STAFF REPORT WEST ALLIS PLAN COMMISSION Wednesday, December 11, 2024 6:00 PM

4. Site, Landscaping, and Architectural Design Review for La Finca, a proposed Restaurant (limited), at 7033 W. National Ave. (Tax Key No. 453-0602-000).

Station No. 6 Outdoor Patio (former parking area)

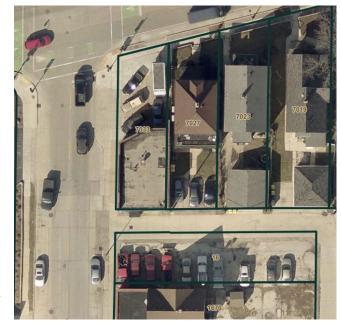
A similar pattern of use can be found in West Allis at Station No. 6. The property at Station No. 6 was formerly used for a light motor vehicle service. The former concrete area used for parking & maintenance of vehicles was transformed into a vibrant patio for patrons to utilize. A similar type of use is recommended by staff for this project.

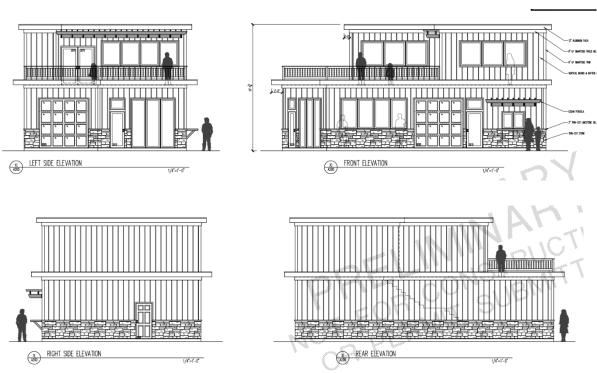
The architectural plan shows an overhaul to the exterior of the existing building. The proposed building features natural cut stone with ledgestone that wraps itself around the base of the entire building. Immediately above the stone is LP board and batten. As an alternative to the natural cut stone and LP siding proposal, the applicant has indicated that their may be an attactive brick underneath the existing metal siding. Staff has encouraged the applicant to remove areas of metal siding to explore what exists underneath, as this could potentially be an attractive option to the proposed.

The elevation along W. National Ave. shows a storefront with an aesthetically pleasing design. A glass door provides access to the building. Next to this door are three large commercial storefront windows. There is also a large overhead garage door, with glass panels, serving as an additional access point. The rooftop patio seating area is also prominently visible from this façade. The visibile second floor features from the street will be the seating area, glass entrance door, store front windows, black rod iron railing, and decorative pergola. Moving to the west facade, this serves as another prominent entry point. Proposed is a glass entry door along with another overhead garage door with glass paneling. Directly next to the glass door is a pedestrian walk-up window where orders can be placed. This feature is complemented by a pergola. Additional storefront windows make their way throughout the first floor of the west façade. Visible on the second floor on the west façade are more windows. The south and east elevations feature less prominent architectural features due to their less visible locations. The south elevation features a door that will be used for the business for needs such as refuse collection.

and 4-sided screening details including consideration of locating refuse area south of alley, (d) the applicant apply for a Commercial On-Street Accessibility Parking Zone permit; (e) removal of test areas of existing metal panel siding to explore restoration of brick as an option of adding new siding; (f) landscaping amenities being located on site including planter boxes, wall-mounted planters, trellises, or other features to enhance streetscape and buffer adjacent properties (g) location of any lighting on the site.

Floor Plan

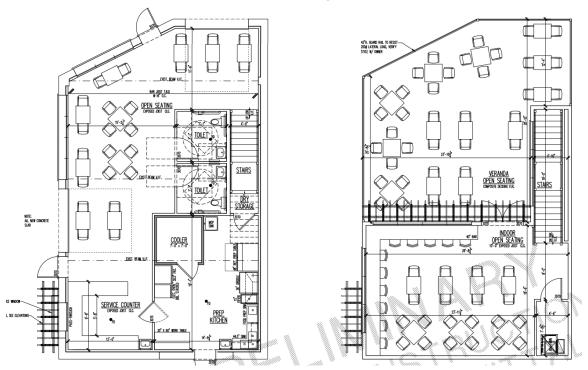
The proposed business shows a revamped floor plan to accommodate for the restaurant use. Customer access to the first floor of the restaurant is provided by entry doors on the north and west sides of the building. Overhead garage doors can also be found providing access to the north and west sides of the building. The floor plan shows an open seating concept making up most of the first floor. Two restrooms are shown along with a prep kitchen, cooler, and dry storage area. Stairs

in the east portion of the building provide access to the second floor. The second floor shows an open seating area with tables and chairs, along with countertop seating. A utility closet is also shown. The indoor area leads directly to the outdoor patio area which includes additional seating.
